ADA Curb Ramp New Construction Inspection Form (Blended Transition)

NW. 314TH AVE

24953

NW. COMMERCIAL ST.

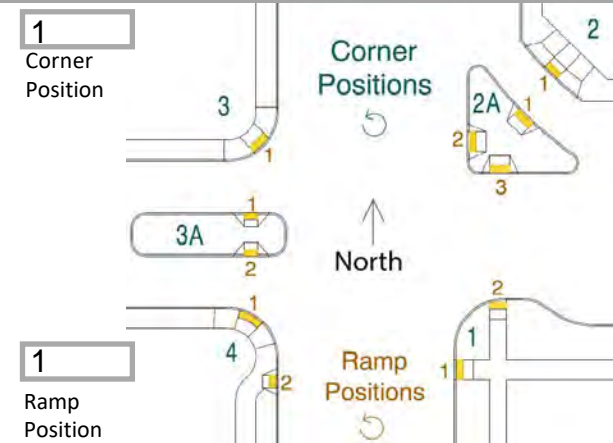
No dome
